**GOVERNMENT OF THE DISTRICT OF COLUMBIA
DEPARTMENT OF TRANSPORTATION**

MEMORANDUM

SUBJECT: ZC Case No. 14-07 – 1270 4th Street NE (EDENS Shapiro)

Figure 1 Site Design and Access (Source: Gorove/Slade)

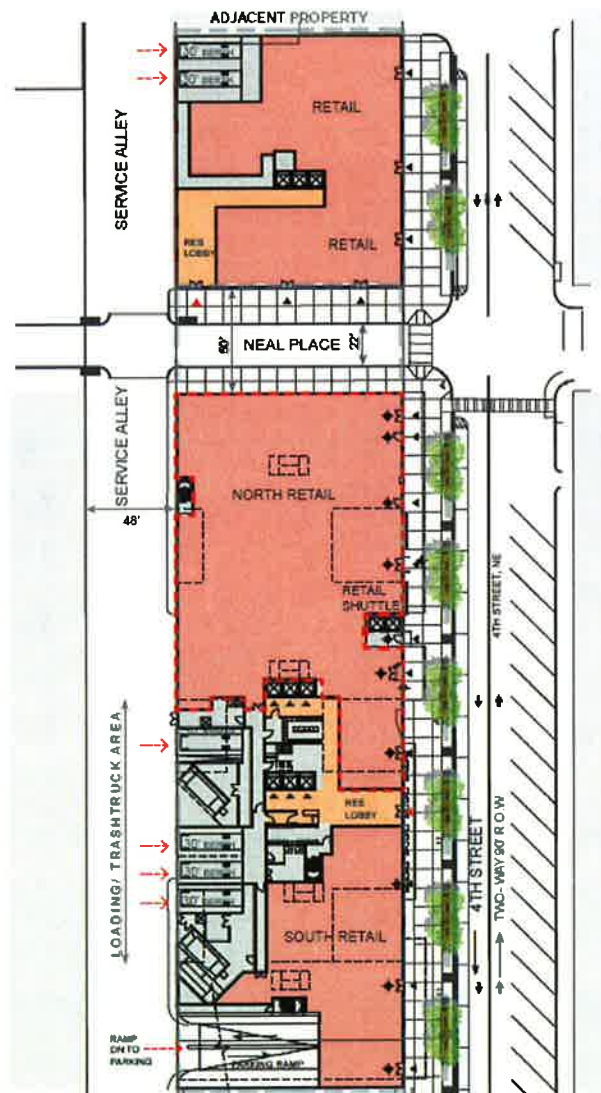
Vehicle site access for both phases of the project is proposed from an alley, in compliance with DDOT standards. Of note, the alley is controlled by the District through the Deputy Mayor for Planning and Economic Development, and is not DDOT right-of-way. See Figure 1 below for details.

The Applicant's plans show a series of canopies extending laterally along a significant portion of the building façade and projecting between 7' - 10' from the building façade. The canopies, as shown, do not meet regulations for canopies and should be revised to comply with regulations. Revisions of the canopies are likely to alter the design of the building. The final design of the canopies will be addressed during public space permitting.

The Applicant's plans show curbside uses that includes angled back-in parking spaces along the east side of 4th Street. DDOT has not approved the proposed curbside uses as shown and does not support angled back-in parking spaces because of its impact to wholesaler operations. The Applicant has agreed to coordinate with DDOT on the development of a curbside management plan for the entirety of 4th Street between Florida Avenue and Penn Street. The details of the plan, which must account for the needs identified above, will be determined as part of the public space permitting process.

Figure 4 - Neal Place Interim Proposal

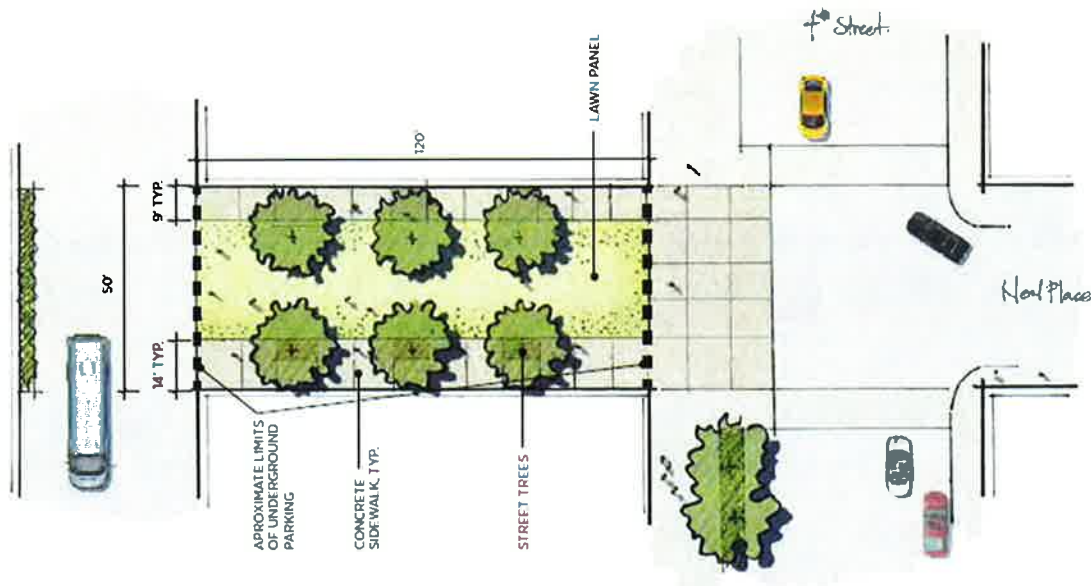
The Applicant proposes an interim park in the Neal Place ROW that transitions to a street in the future. The interim condition would involve building out the sidewalk and tree box components of the extension and portions of the underlying roadbed infrastructure, but would include a park in place of the 22' cart path. Some construction would be required in order to transition from the interim park use to the final road condition. The Applicant estimates that conversion, including the securing of necessary permits, could take up to 12 months.

As discussed above, the Neal Place extension is critical to disperse site-generated traffic and support development within the Market, particularly developments to the west of 4th Street. While a temporary use of the space as a park may be appropriate, it is critical that the interim use be limited only to times when the connection is not needed to support development in the Market or for dispersing site-generated traffic to improve the operations in the vicinity.

DDOT finds these triggers as a good basis for transitioning from an interim use to the final condition, but the following adjustments are needed to provide greater assurances that the Neal Place extension opens in a timely manner:

Prior to the issuance of a certificate of occupancy for the South Parcel building, the Applicant shall demonstrate that it has constructed the interim Neal Place extension improvements as shown on the Interim Neal Place Extension Plan.

As soon as possible but within 12 months of the issuance of the certificate of occupancy for the South Parcel building, on an annual basis thereafter, or within six weeks of DDOT requesting additional observation within the yearlong period, the Applicant shall initiate a performance monitoring study of the length of queues along the northbound 4th Street approach to Morse Street (“Monitoring Study”). Each Monitoring Study shall consist of video-based observations for two (2) observation periods during a three (3) week timeframe. An observation period is defined as Wednesday – Saturday peak periods. The weekday peak period is defined as between the hours of 4 to 7 pm when DC Public Schools and Congress are in session. The weekend peak period is defined as between 11 am – 2 pm during a Saturday during a week when DC Public Schools and Congress are in session. The Applicant shall provide a copy of each Monitoring Study, including the video footage, to DDOT.

The Applicant shall secure the necessary funds in an escrow account and shall design and construct the final Neal Place extension improvements as shown on the Final Neal Place Extension Plan and open the Neal Place extension to vehicular traffic within twelve (12) months of the earlier of the following events. When:

- After review of a Monitoring Study that demonstrates queuing extending more than 150’ on 4th Street south from Morse Street toward Florida Avenue on more than one (1) observation day, and DDOT concludes and communicates to the Applicant that the Neal Place Extension is needed to alleviate traffic queuing conditions at 4th and Morse Street. Each Monitoring Study should document whether queuing was the result of

typical traffic patterns or the result of atypical traffic events (e.g. construction, holidays, or special events); or

- DDOT communicates to the Applicant that all required permits have been issued for the proposed 3rd Street NE as a public or private street, alley, or driveway connection serving vehicular traffic; or
- DDOT communicates to the Applicant that all required permits have been issued for Neal Place to the immediate west as a public or private street, alley, or driveway connection serving public vehicular traffic; or
- After 5 years from the issuance of the certificate of occupancy for the South Building.
